INDESIT company

MBA45D1NFFR

F028561

Technical Documentation guidelines

0999342: Aluminium separator dimentions

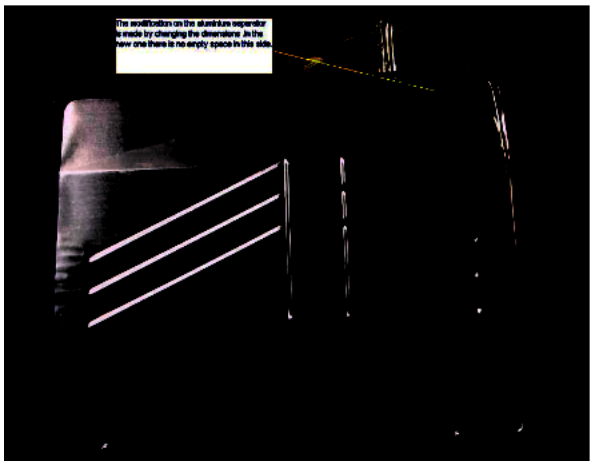
Modification on the aluminium separator is made by changing the dimentions. On the new one there is no empty space at the corner.Spare part code remain the same.

0999344: length of rezistance

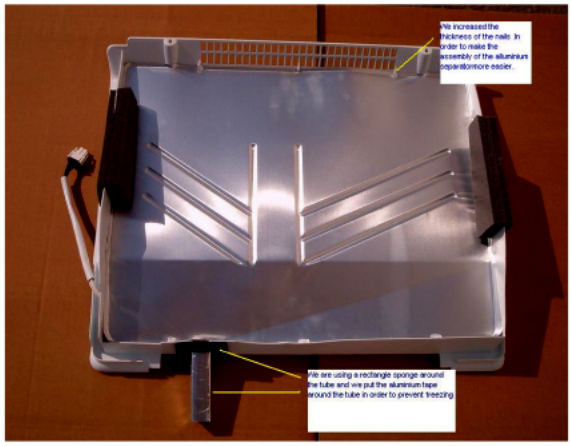
Length of rezistance which is placed on aluminium seperator has been increased.
